AME HARLEY-DAVIDSON SERVICE BULLETIN

No. M-758

SAFETY DEFECT CODES 043 AND 044

RETURN OF UNUSED PARTS FROM DEALER STOCK

CORRECT BRAKE PEDAL SHOWING DATE CODE

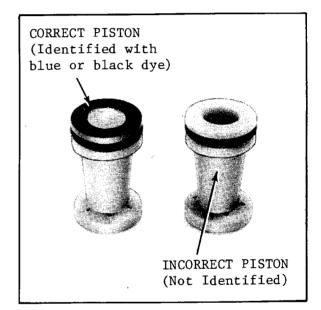
<u>Safety Recall</u> 043 (Service Bulletin No. <u>M-755</u>). Rear Brake Pedal 42410-75A. Correct part must have a date code in addition to casting part number underneath the pedal pad as shown. Return all pedals which do not have a month identification code.
